Torque Converter Flex Lock-up Shudder

YEAR(S)	MODEL(S)	ADDITIONAL INFORMATION
2012 – 2014	Camry	VDS(s): BF1FK

REVISION NOTICE

SUPERSESION NOTICE

Figure 1. Magnet Installation Locations

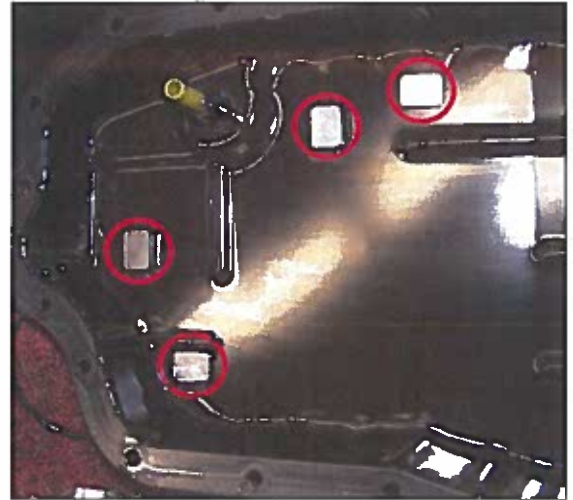
6. Install 4 NEW magnets in the locations shown in Figure 1.

Figure 2. Location of Authorized Modifications Label on 2012 – 2014 Camry

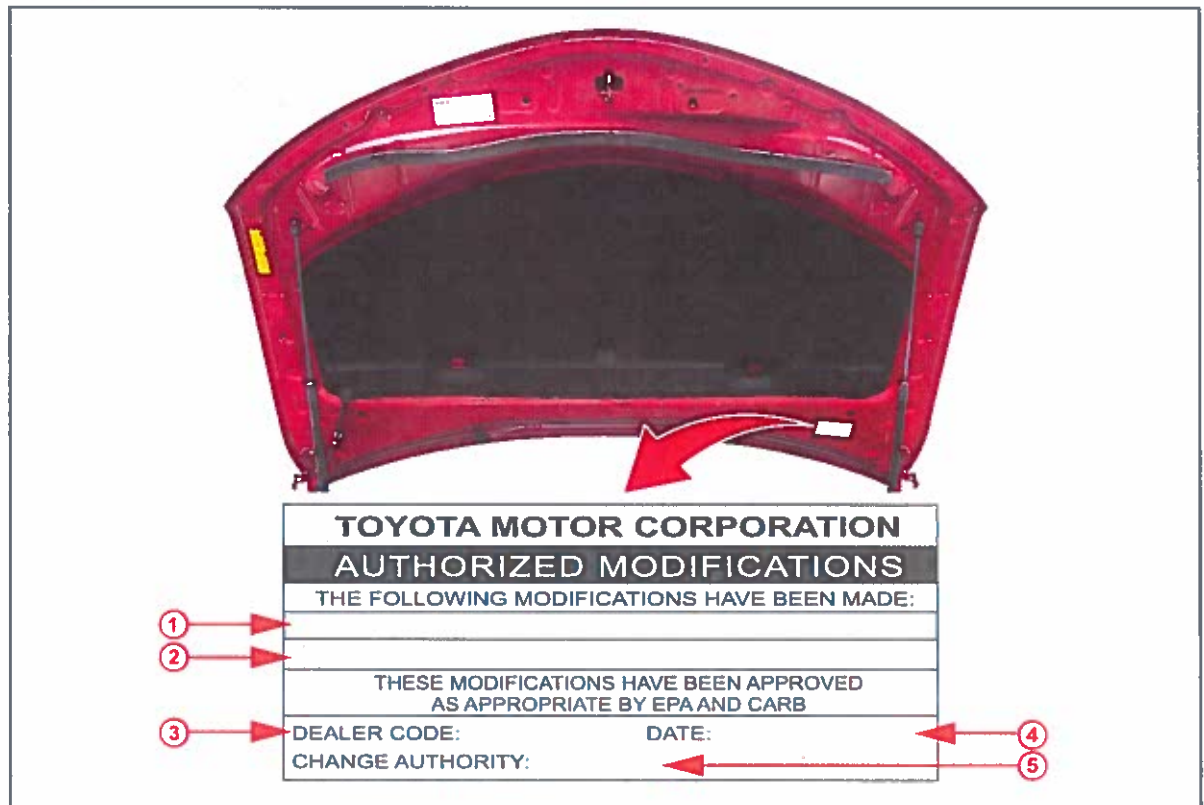
- Check for the Authorized Modifications Label affixed to the vehicle in the location shown in Figure 2 below. Confirm if the ECM (PCM) calibration has been updated. If the calibration ID listed is NOT the latest ECM (PCM) calibration — go to step 10. If the calibration ID is the latest, go to step 12.

B. Affix the Authorized Modifications Label to the vehicle at the location shown in Figure 2. The Authorized Modifications Label is available through the MDC, P/N 00451-00001-LBL.
